Official Transcript of Proceedings  
NUCLEAR REGULATORY COMMISSION

Title: Advisory Committee on Reactor Safeguards  
U.S. EPR Subcommittee - Open Session

Date: Tuesday, April 5, 2011

U.S. EPR SUBCOMMITTEE MEETING

## Peak Containment Temperature

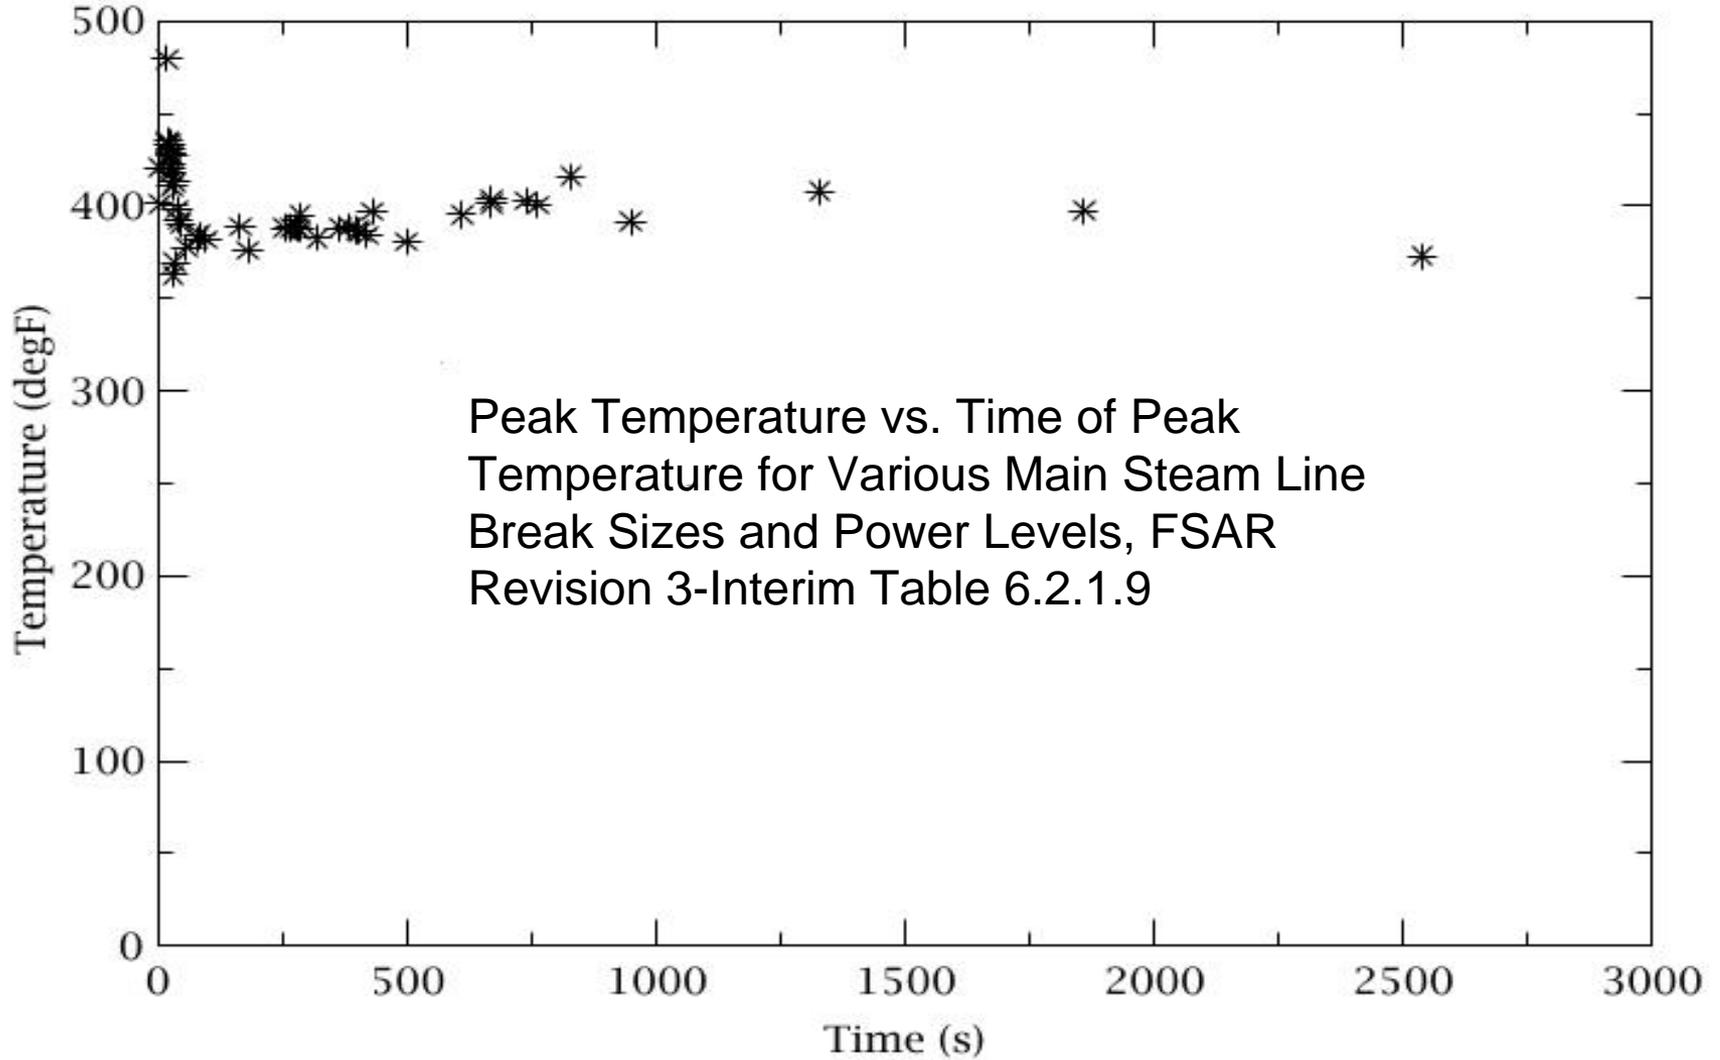
4 And show, this is a locus of the peak  
5 temperature as calculated for the spectrum of main  
6 steam line breaks in the FSAR. It stays at the  
7 temperature, it's fairly high. I think the design  
8 temperature for this plan is like 338. So AREVA is  
9 working on an EQ curve for the instrumentation.

23 MR. MOLSEED: Yes, this is Chris Molseed  
24 with AREVA, again. Walt is correct. This is a peak  
25 temperature and it's reported throughout the building.

#### **Staff Evaluation**

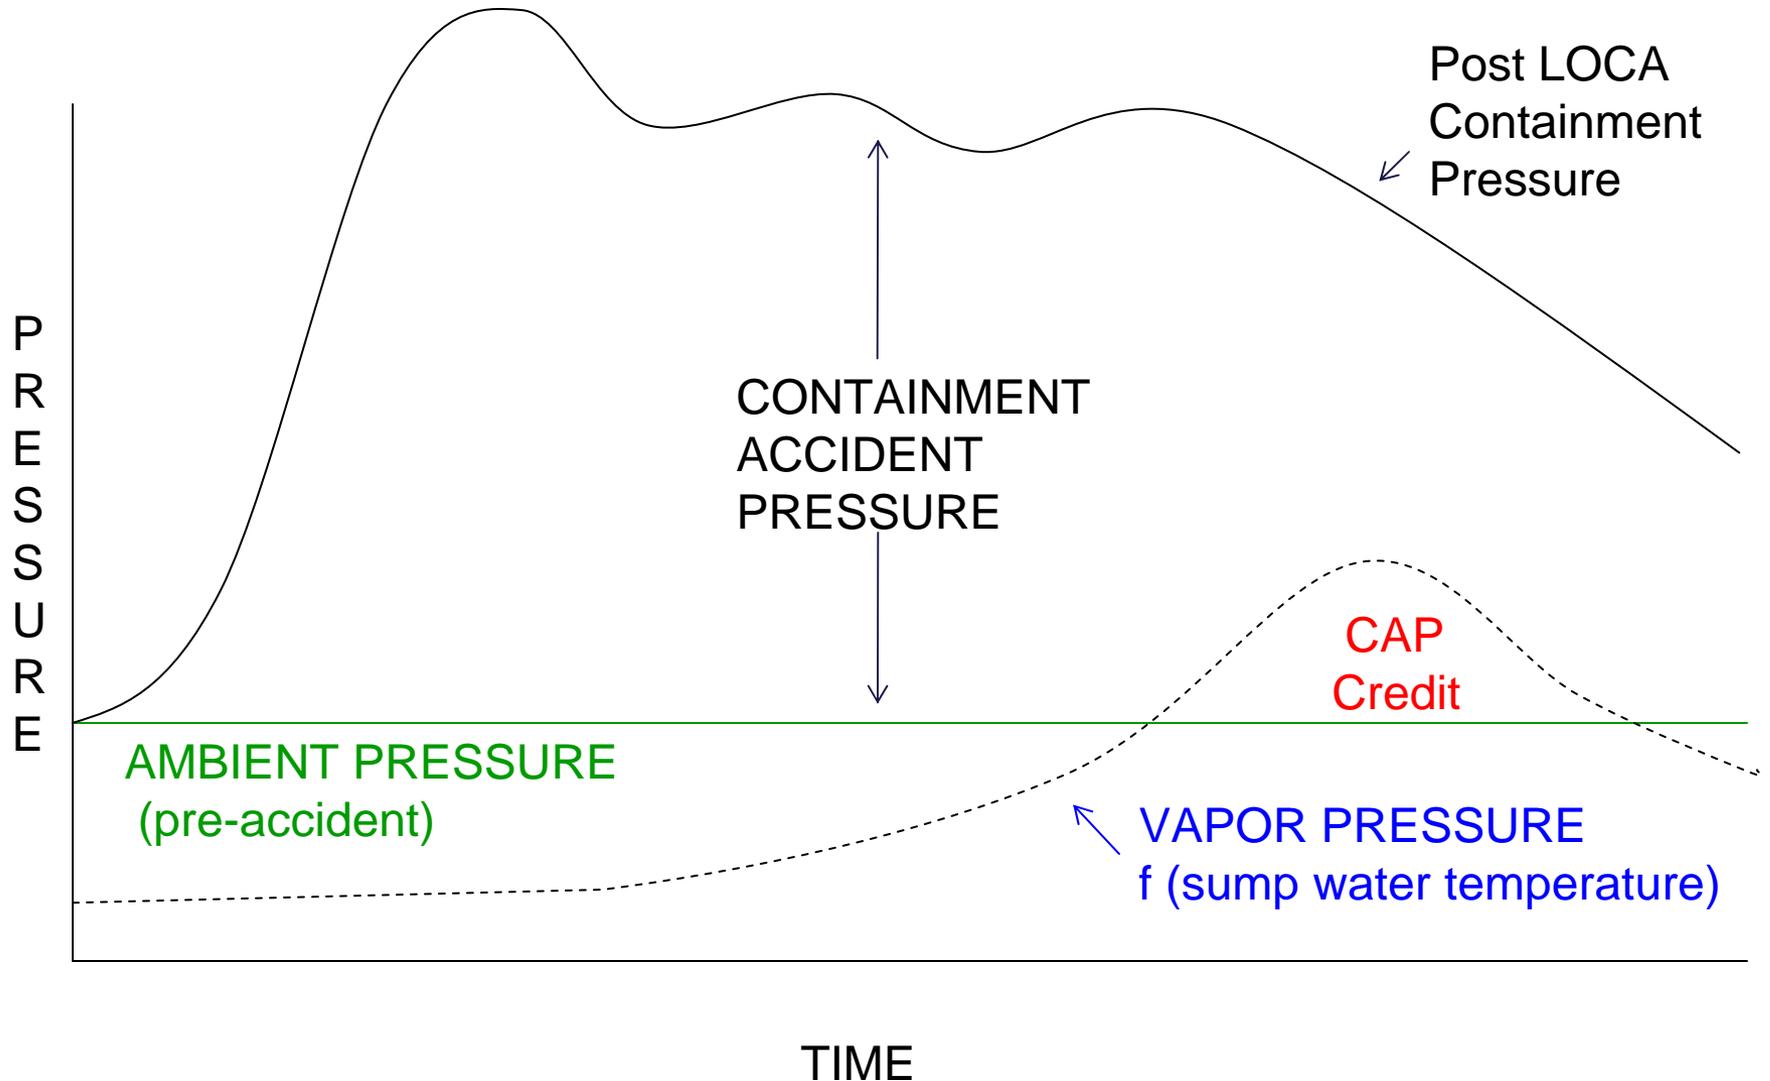
- The calculations cited by the applicant do not follow the recommendations of RG 1.82. The applicant has not yet provided a complete evaluation of NPSH using appropriate assumptions, including the use of containment accident pressure (CAP).

- RAI 416, Questions 06.03-15 requests that the applicant justify why the selected approach, use of CAP to support ECCS NPSH analysis, is acceptable.
